**FINAL DRAINAGE REPORT
FOR
A-1 CHIPSEAL
LOT 36 AND 37 CLAREMONT BUSINESS PARK FIL NO 2
7245 COLE VIEW
COLORADO SPRINGS, COLORADO**

TNE Job No. 2173.00
County Job No. COM-22-014

Figure 9-39. Riprap erosion protection at rectangular conduit outlet (valid for $Q/WH^{1.5} \leq 8.0$)

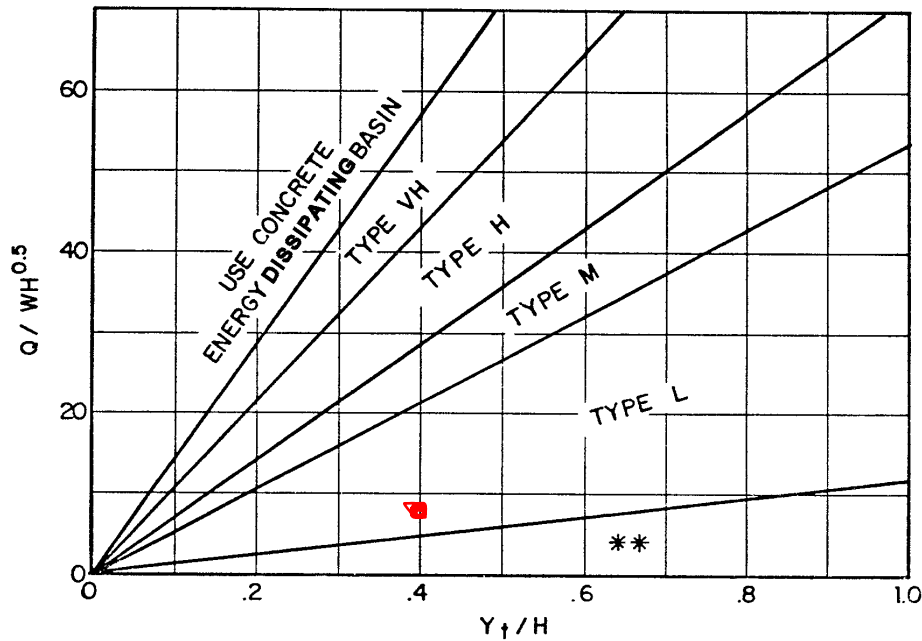
Type M riprap is used when only Type L is necessary for sand filter.
